Amendments to the Drawings

REMARKS

FIG. 3

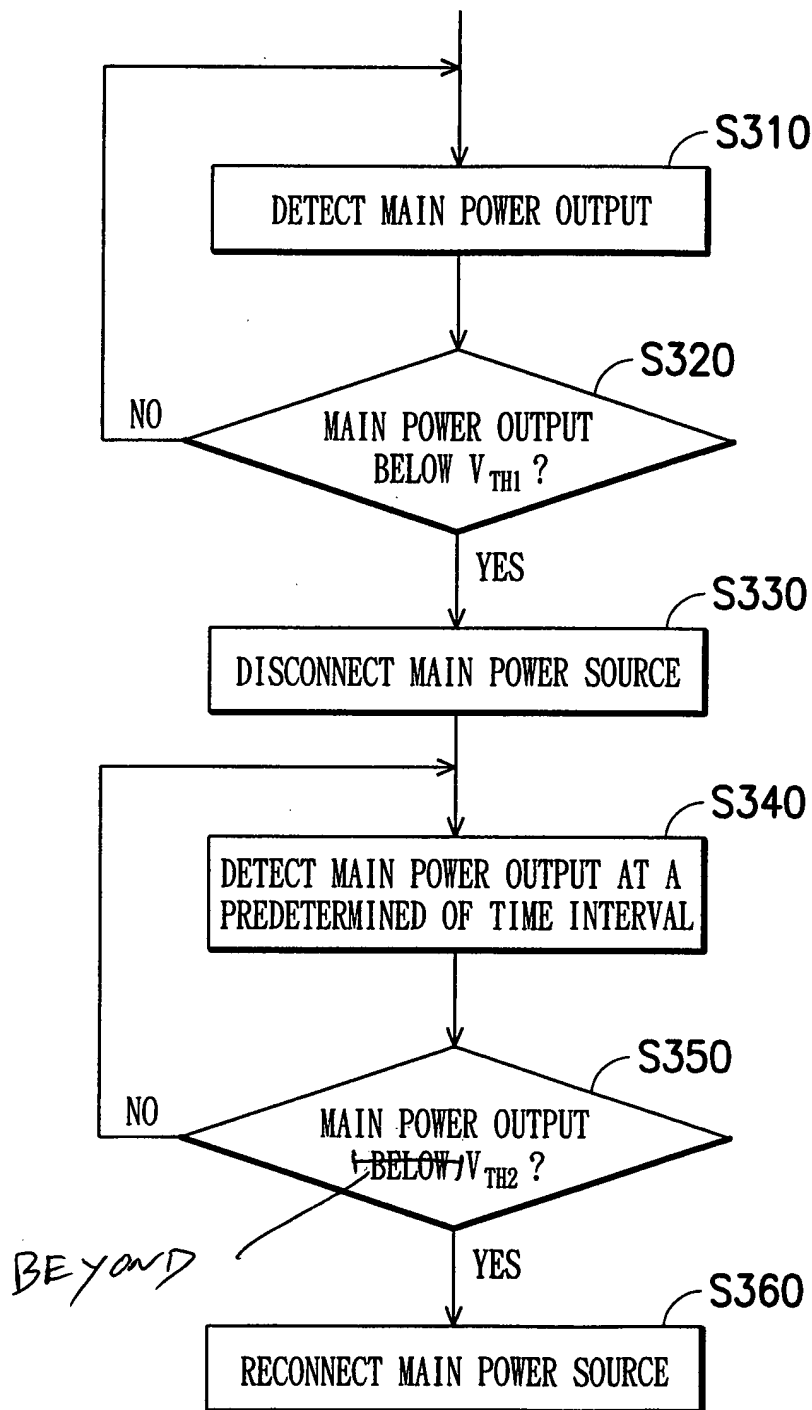
The attached sheet of drawings include proposed changes to Fig. 3 and replace original sheet 3 including Fig. 3. In Fig. 3, the text in step S350 has been corrected to recite: "MAIN POWER OUTPUT ~~BELOW~~ BEYOND V_{TH2} ".

Figure 3 of the drawings has been corrected for clarity purpose, by reciting for step S350: "MAIN POWER OUTPUT ~~BELOW~~ BEYOND V_{TH2} ?" in conformity with the language of paragraph [0016] of the specification. No new matter has been added.
